# Access Compliance Report

## Public Rights-of-Way

### (Curb Ramps)

Intersection ID: 13237	Main Street: W_PARK_AV	Cross Street: WILMORE_DR	Location: SW
ADA ID: 73892CCC4B91	Ramp Type: PerpDiag	Initial Pass/Fail: Fail	Overall Compliance: No
Severity Score: 12.5			
Codes/Mitigation Info/Possible Solution		Field Measurements/Component Compliance

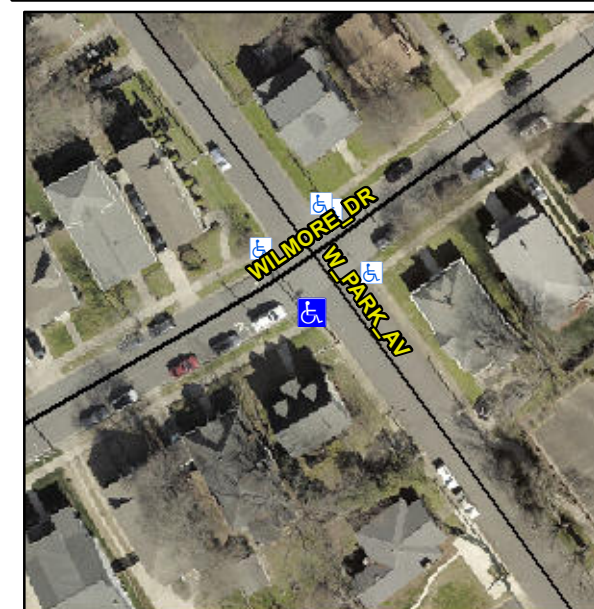
**R304.2.2**

Compliance	Description	Data	Compliance	Description	Data
N/A	Ramp Length (in)	51.0	No	Ramp Slope (%)	11.1
Yes	Ramp Width (in)	50.0	Yes	Ramp XSlope (%)	0.8
N/A	Flare Type LT	N/A	N/A	Flare Type RT	N/A
N/A	Flare Slope LT (%)	N/A	N/A	Flare Slope RT (%)	N/A
N/A	Flare Traversable LT?	N/A	N/A	Flare Traversable RT?	N/A
N/A	Landing Length (in)	N/A	N/A	DWS Provided?	N/A
N/A	Landing Width (in)	N/A	N/A	DWS Contrast?	N/A
N/A	Landing Slope (%)	N/A	N/A	DWS Length (in)	N/A
N/A	Landing X Slope (%)	N/A	N/A	DWS Full Width?	N/A
N/A	Landing Curb? (Y/N)	N/A	N/A	DWS Offset (in)	N/A
N/A	Shared Landing?	N/A			
N/A	Gutter Ponding?	N/A	N/A	Gutter Slope (%)	N/A
N/A	Gutter Lip Ht (in)	2.0	N/A	Gutter X Slope (%)	N/A
N/A	Painted X Walk1?	No	N/A	Painted X Walk2?	No
	X Walk 1 Direction	To NE		X Walk 2 Direction	To NW
N/A	X Walk 1 Width (in)	N/A	N/A	X Walk 2 Width (in)	N/A
	X Walk 1 Slope (%)	6.0		X Walk 2 Slope (%)	11.1
	X Walk 1 X Slope (%)	2.9		X Walk 2 X Slope (%)	2.3

**Remove & Replace Curb Ramp With Two New Directional Ramps or Equivalent.**
